SITE 1A & 1B  
ALATUS – MULTIFAMILY HOUSING 1 &  
ENTREPRENEURIAL MARKET  
CIVIL DRAWING INDEX

BROOKLYN  
CENTER -  
ALATUS -  
MULTIFAMILY  
HOUSING 1

ALATUS -  
MULTIFAMILY  
HOUSING 1 - CIVIL  
NOTES AND  
LEGEND

C100

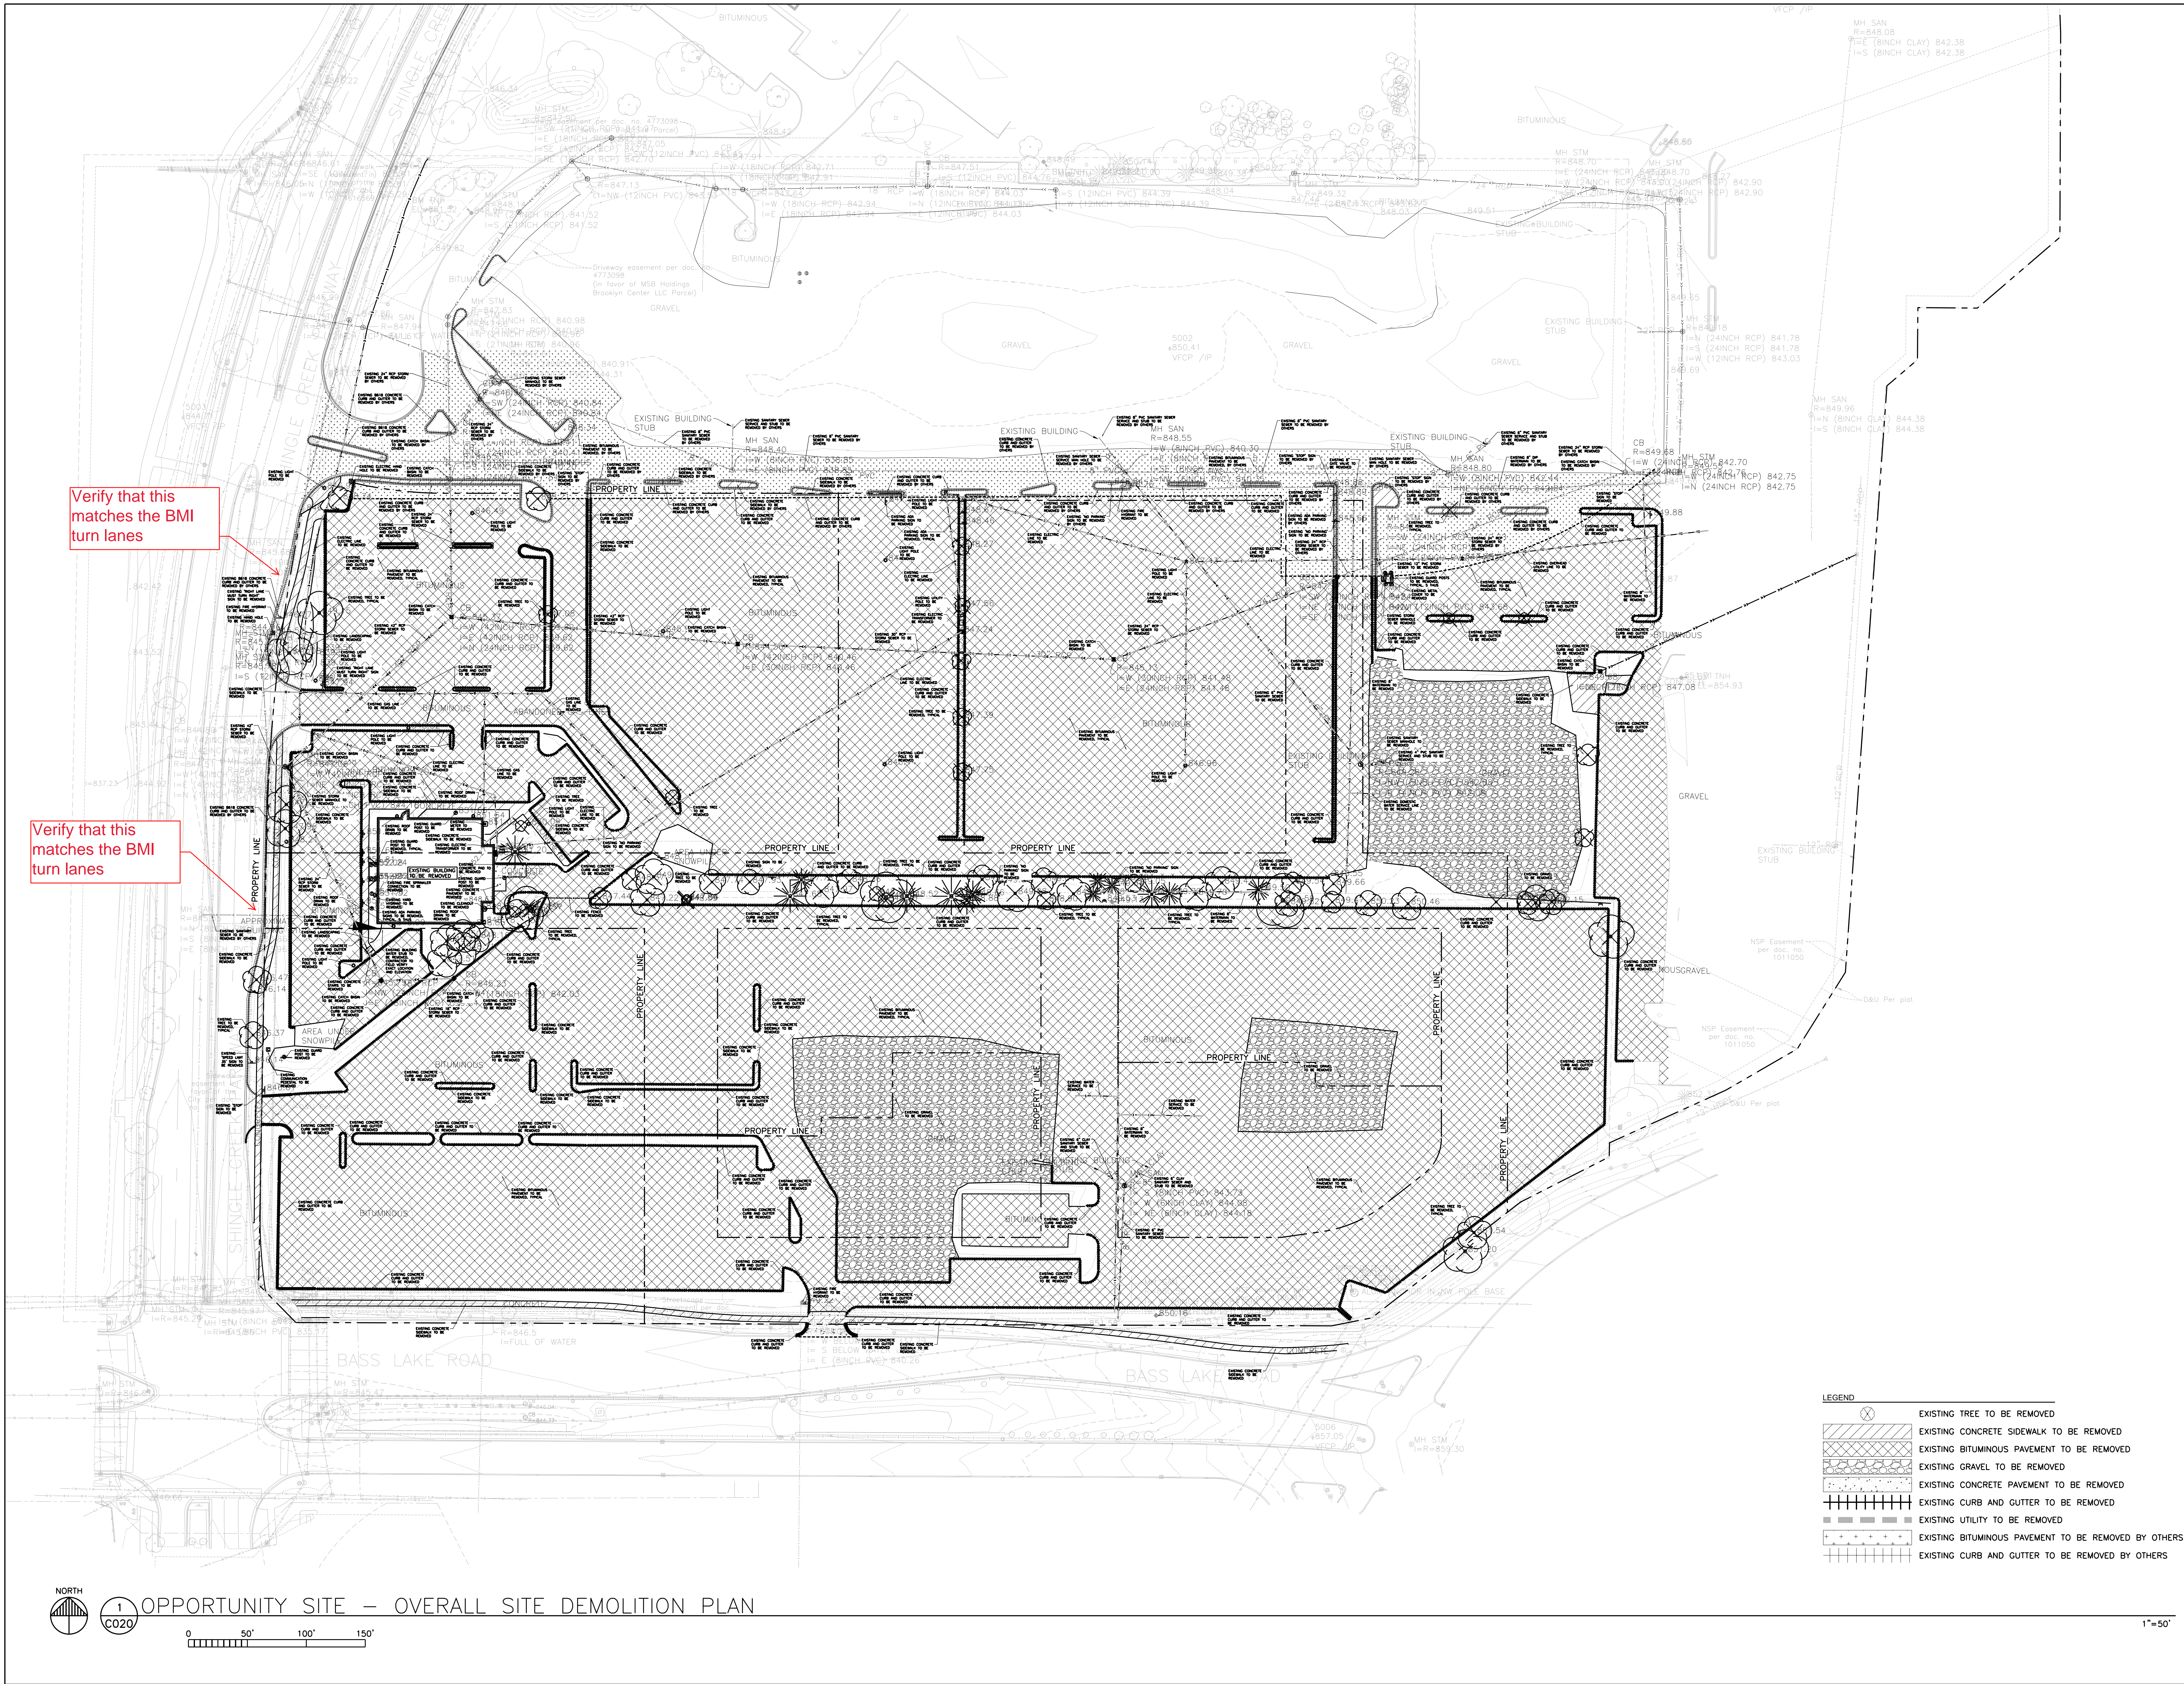
Class 52 for 4" and larger

Provide plan a min. 14 days in advance.

ALATUS -  
MULTIFAMILY  
HOUSING 2 -  
SITE DEMOLITION  
PLAN

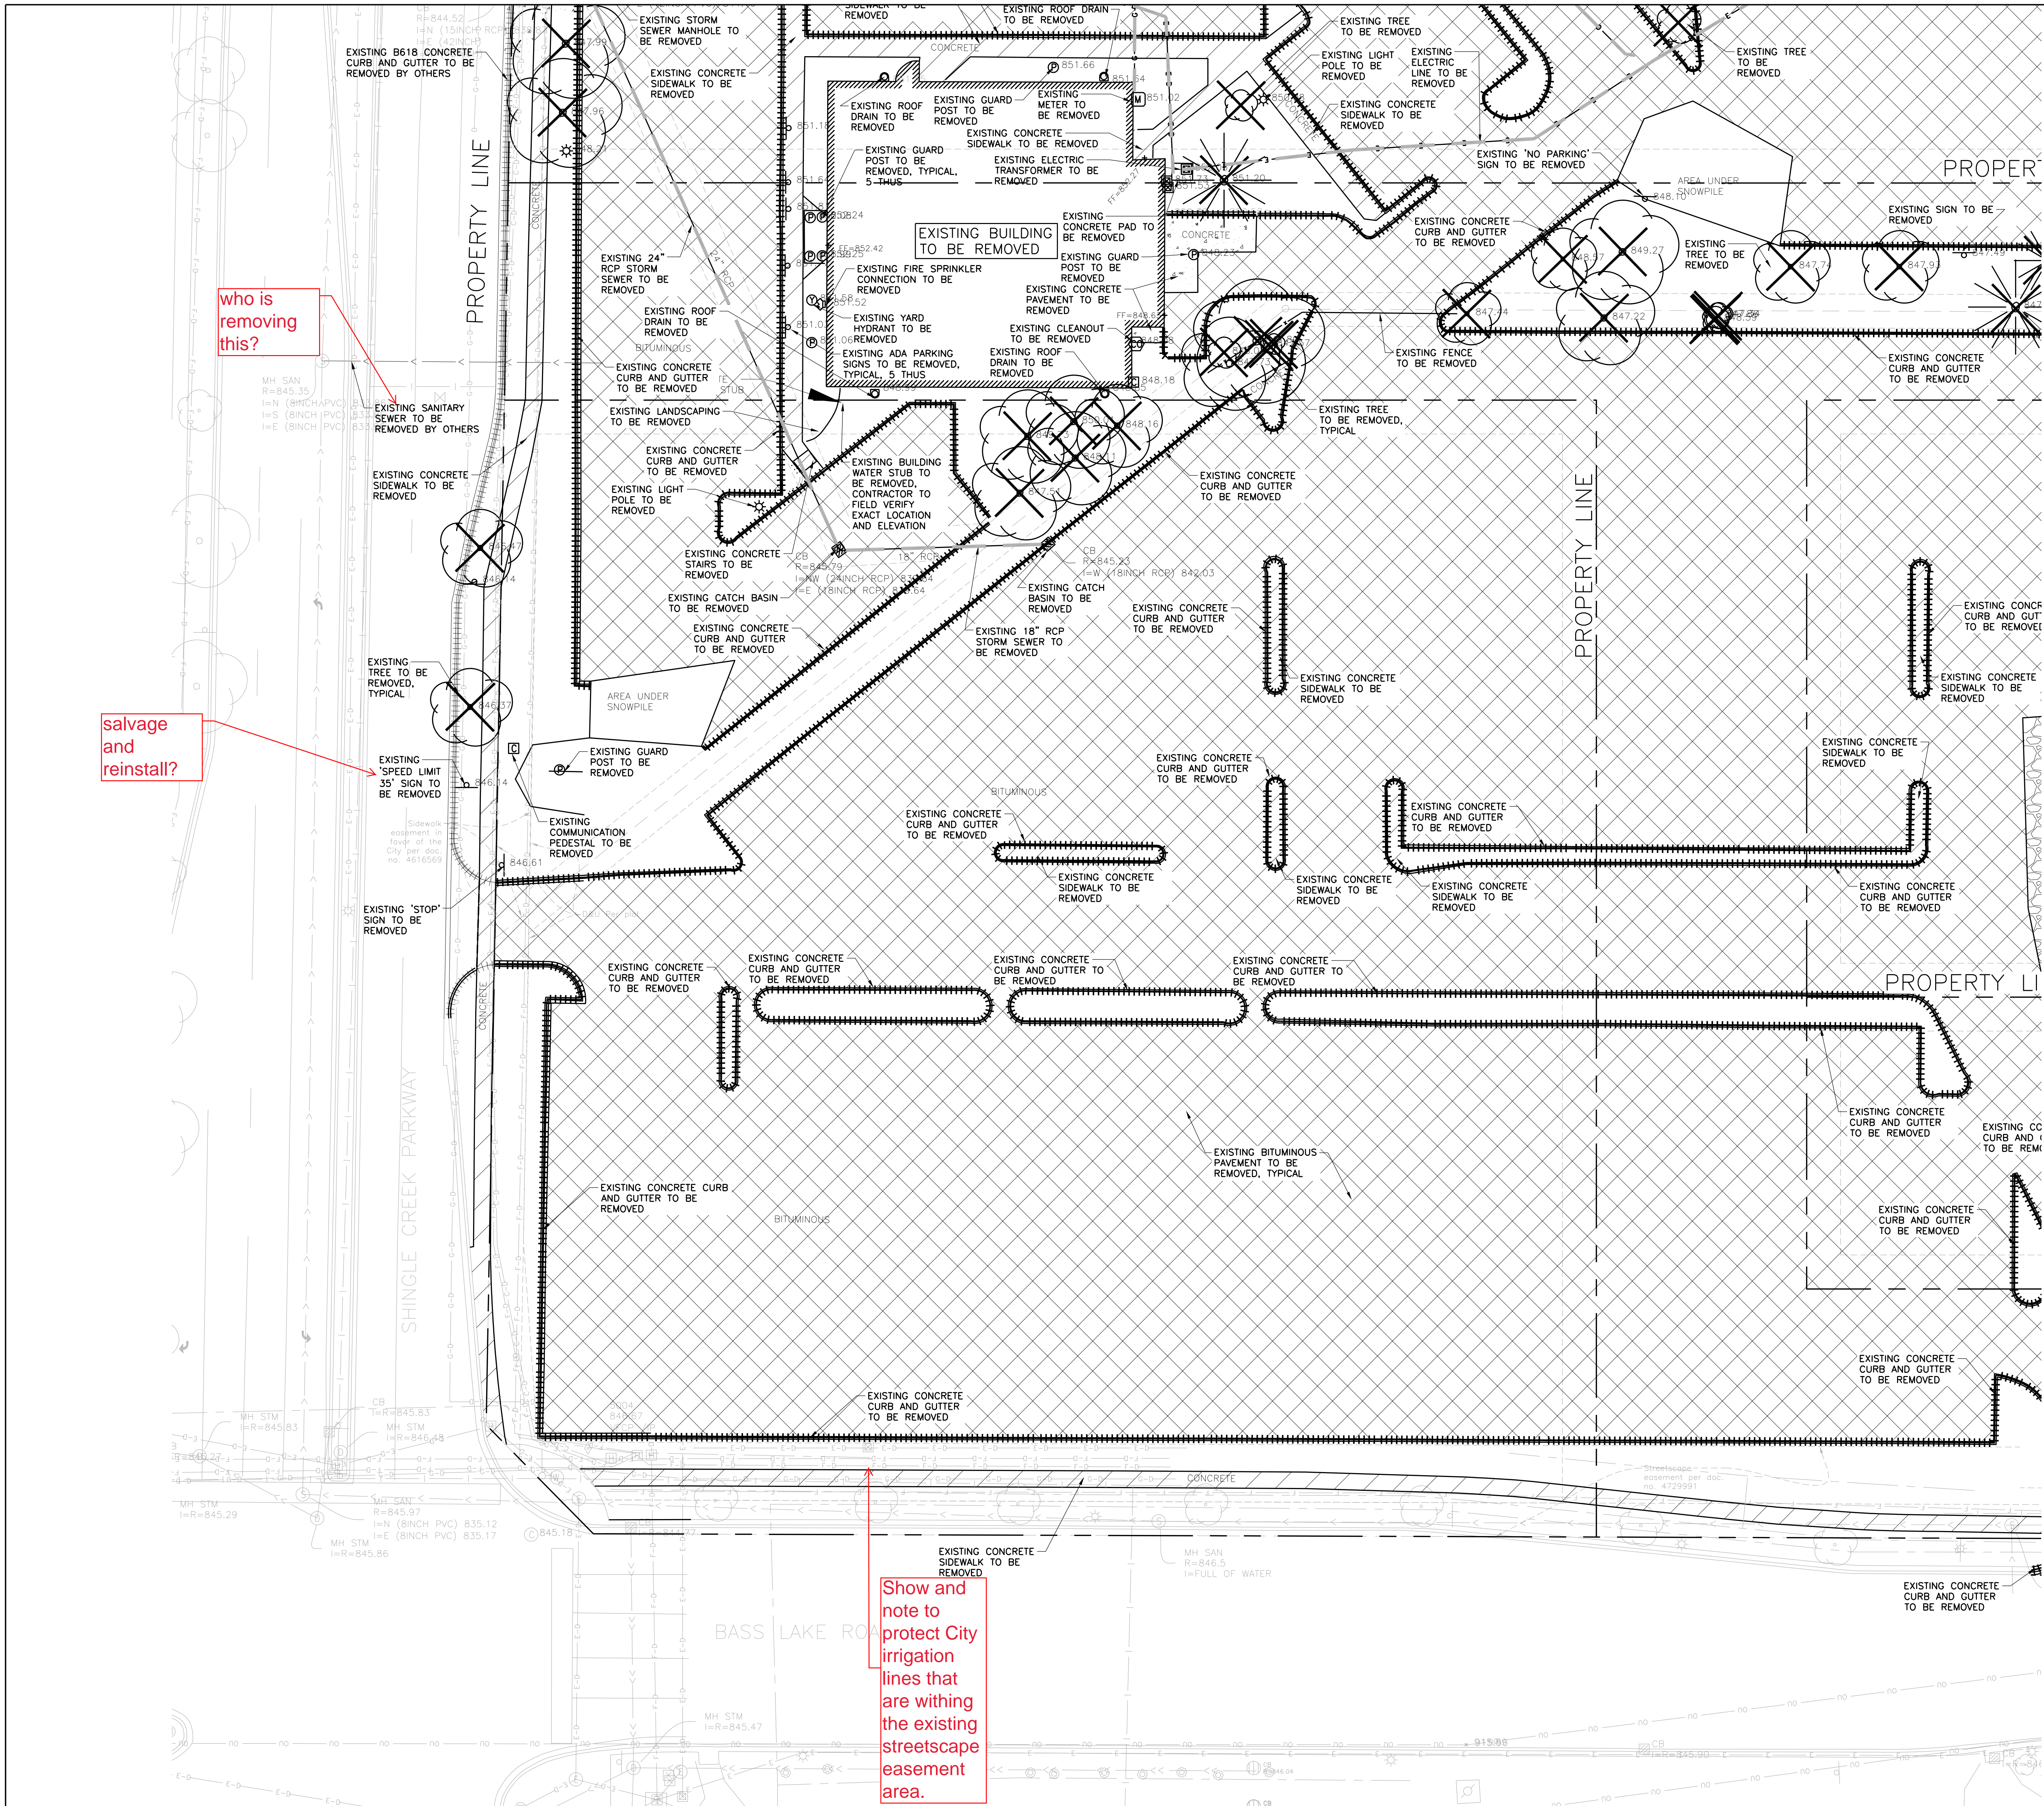
who is removing this?

salvage and reinstall?

Show and note to protect City irrigation lines that are within the existing streetscape easement area.

SWPPP NARRATIVE

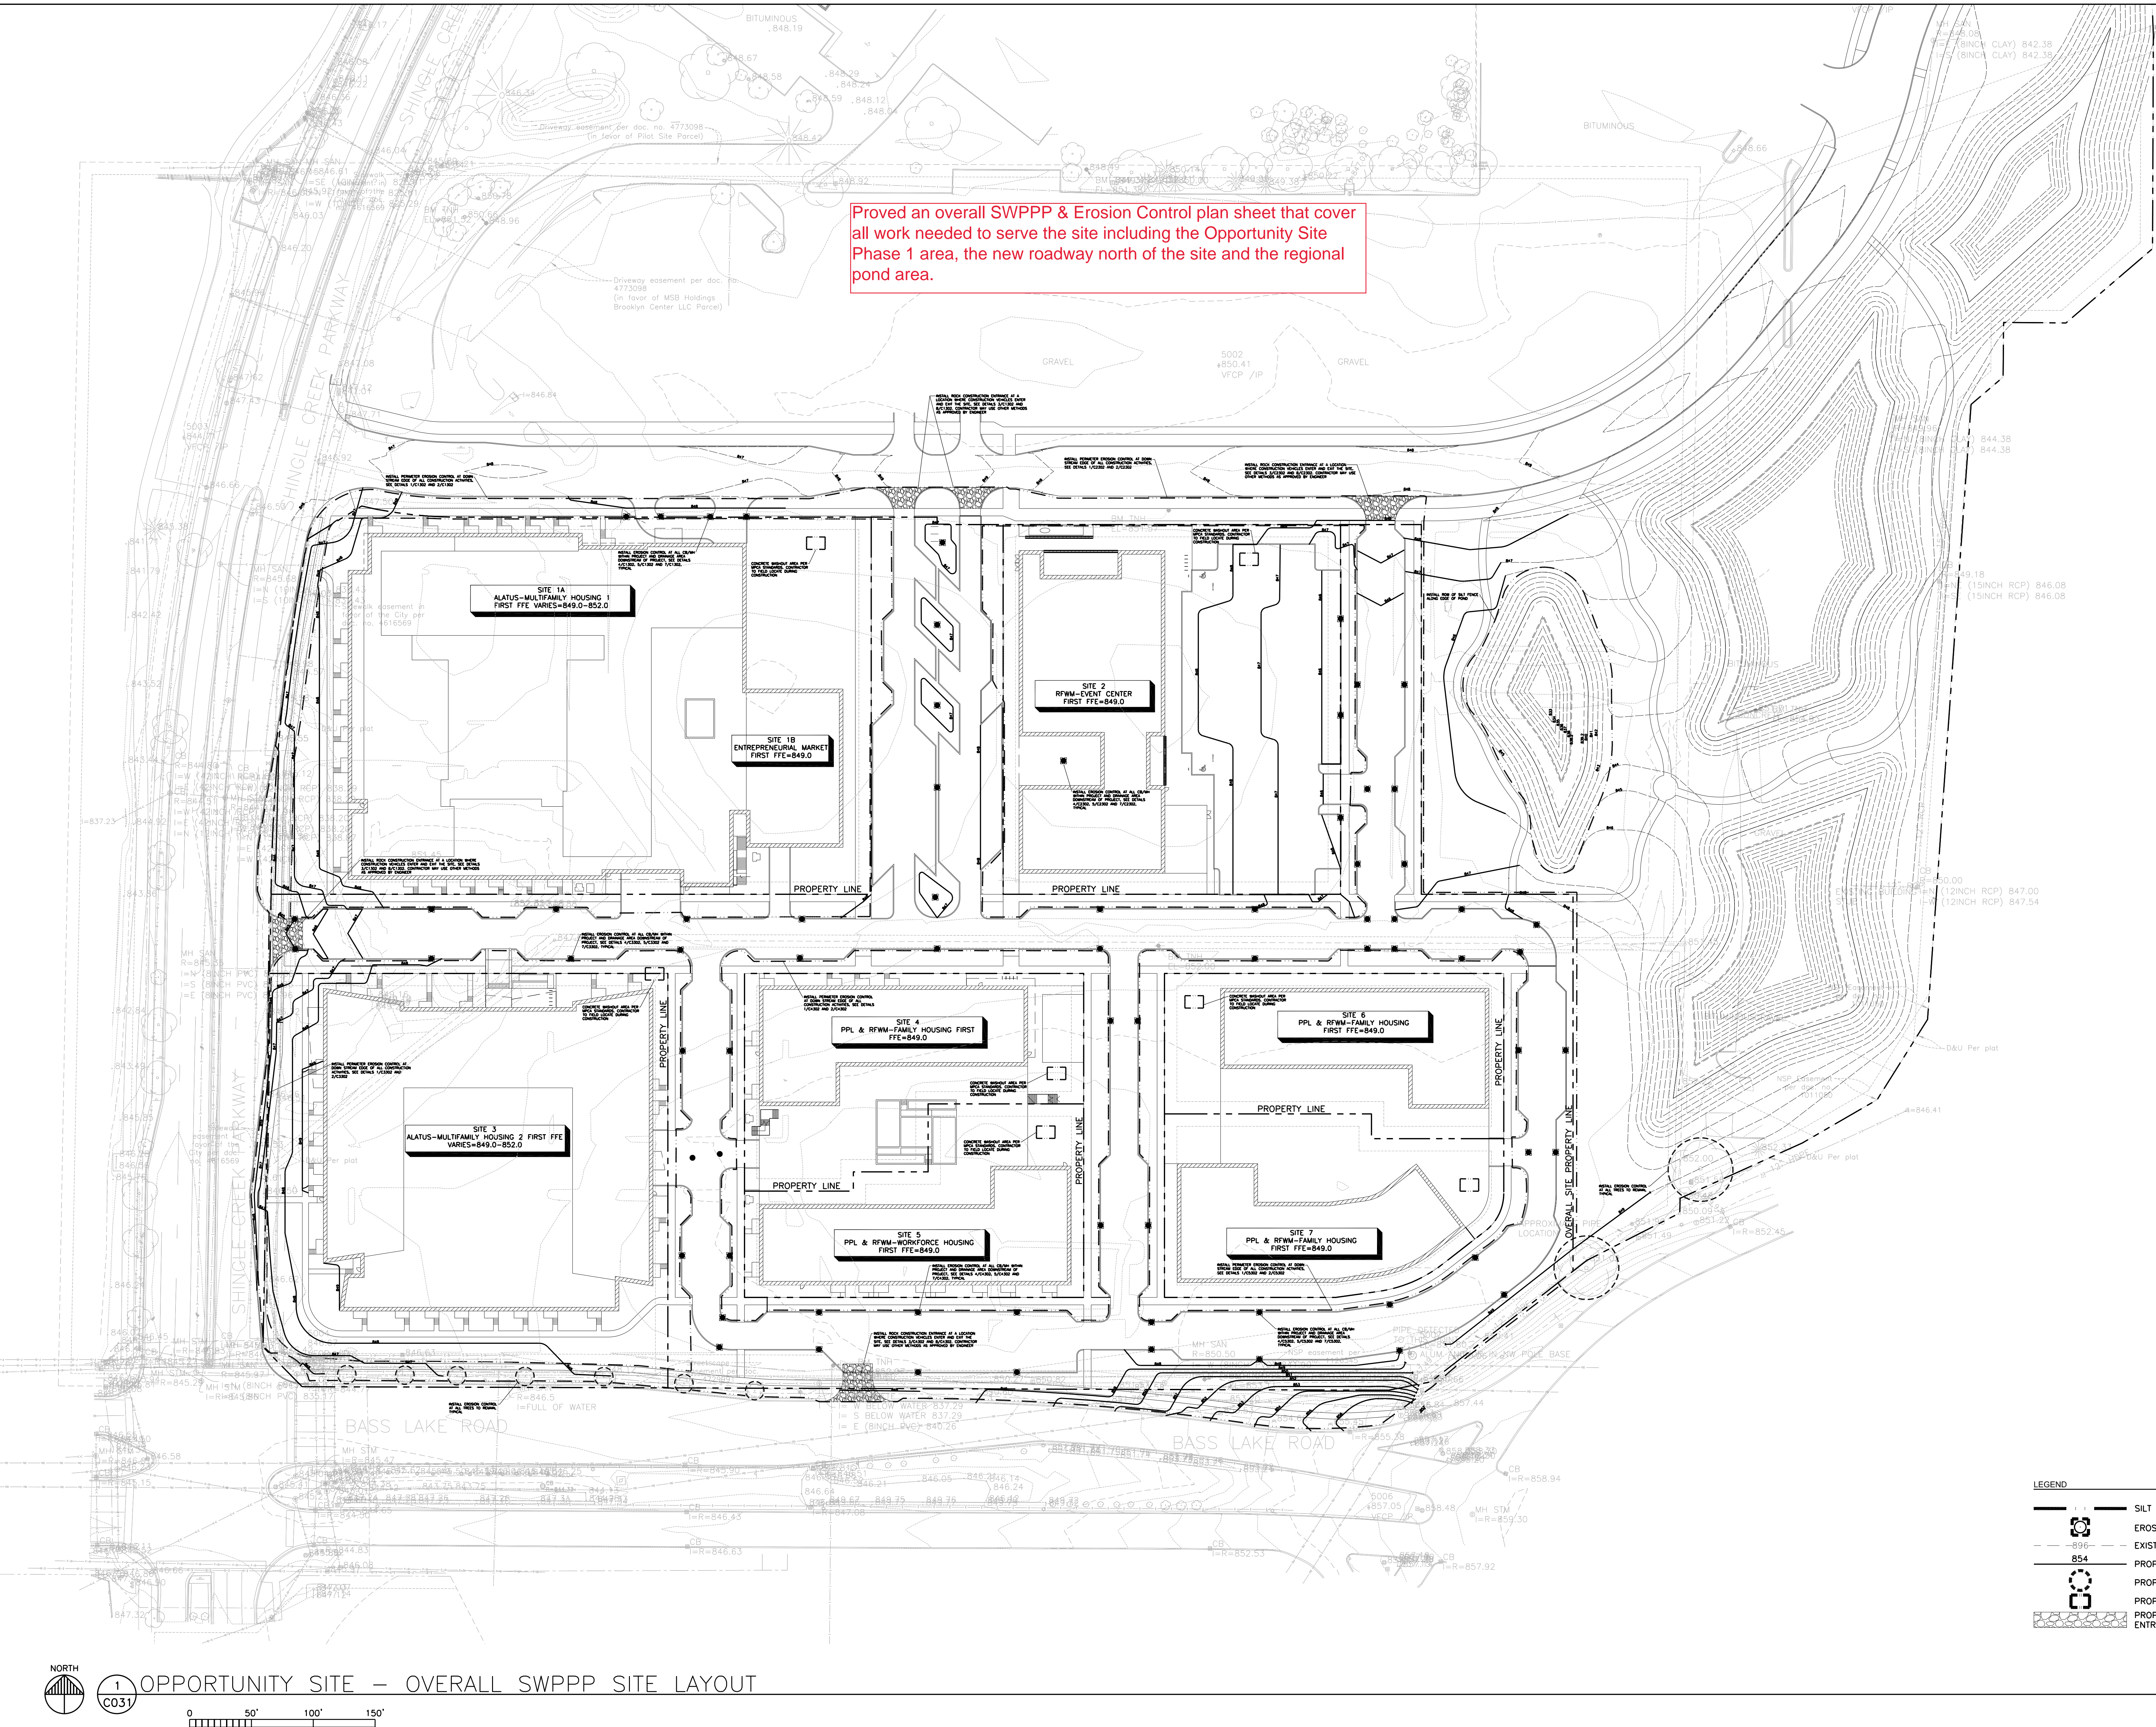
Proved an overall SWPPP & Erosion Control plan sheet that cover all work needed to serve the site including the Opportunity Site Phase 1 area, the new roadway north of the site and the regional pond area.

Provide additional information on what this means
